MACQUARIE POINT MULTIPURPOSE STADIUM

Project of State Significance
Stadium Design Amendment Report

January 2025

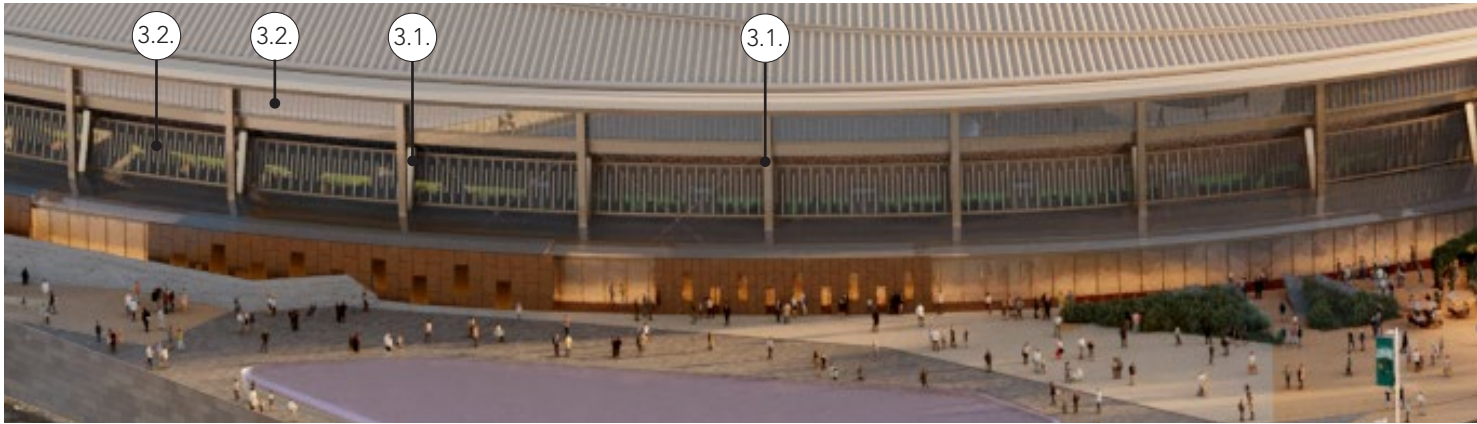
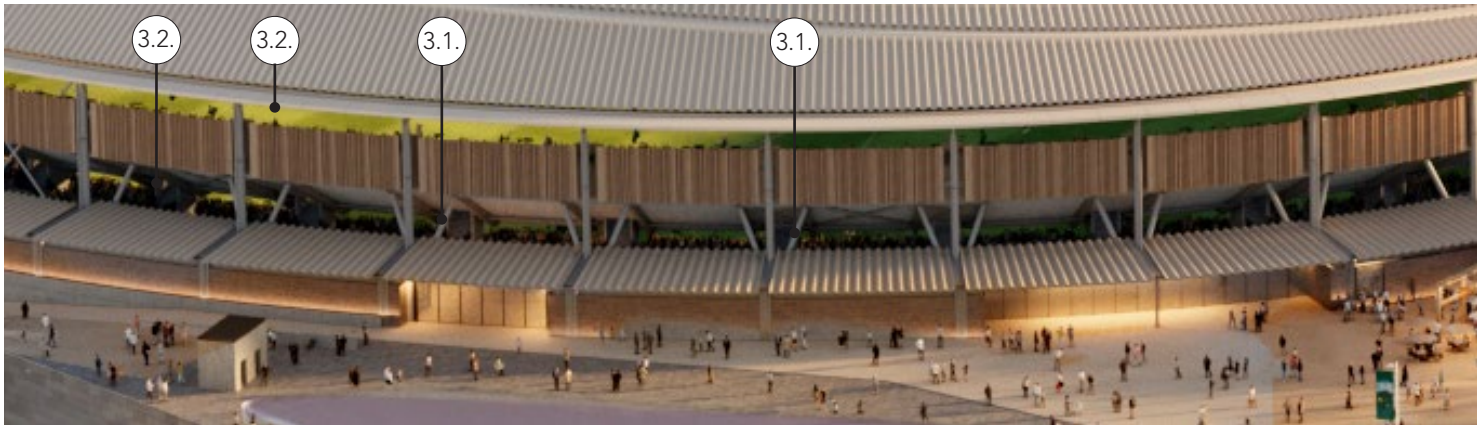
Item 1 - Façade Materials	
PoSS September 2024, Revision: P1	Design Amendments
	The façade materials align with the intent outlined in the September 2024 submission, with refinements made during the design development phase. 1.1. Blockwork used instead of metal cladding for the general admission concourse amenity pods.
PoSS January 2025, Revision: P2

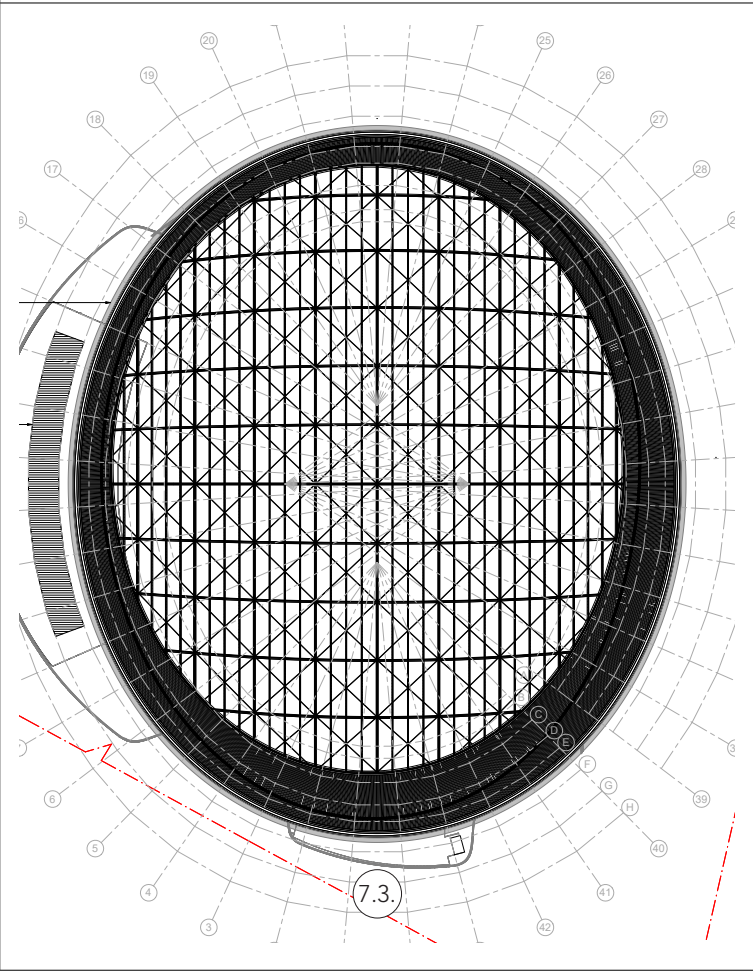
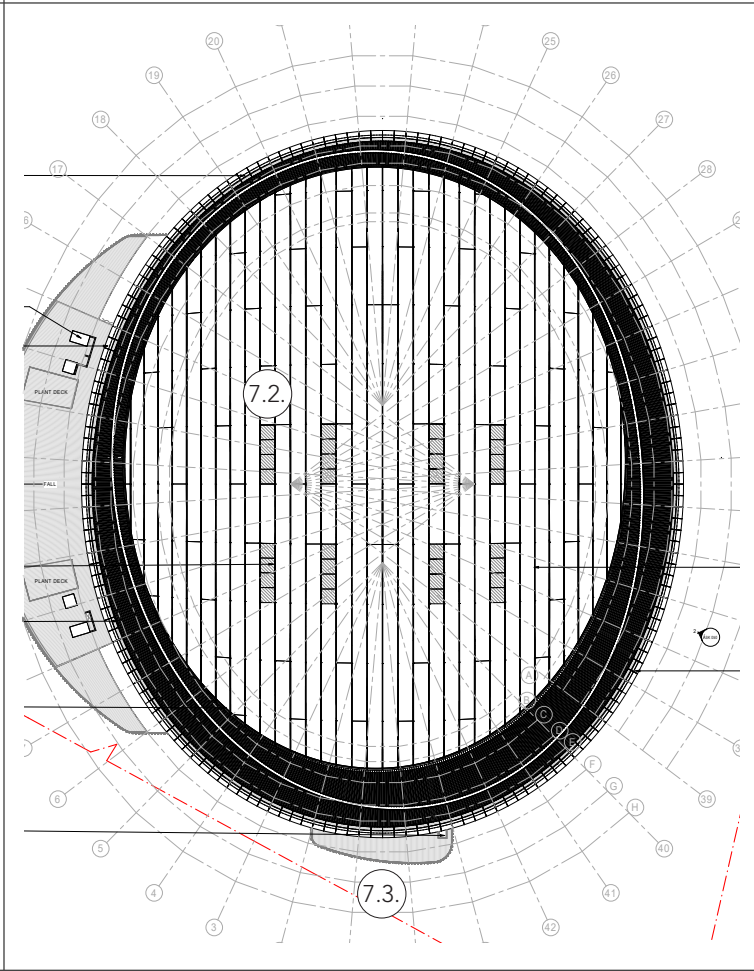
Item 5 - External Eastern Concourse Circulation		
PoSS September 2024, Revision: P1	PoSS January 2025, Revision: P2	Design Amendments
		5.1. East pedestrian ramp replaced with lifts and stairs; ramp extent reduced for vehicle-only access. 5.2. Eastern egress stair realigned. Stair accessible from both the north and south direction.
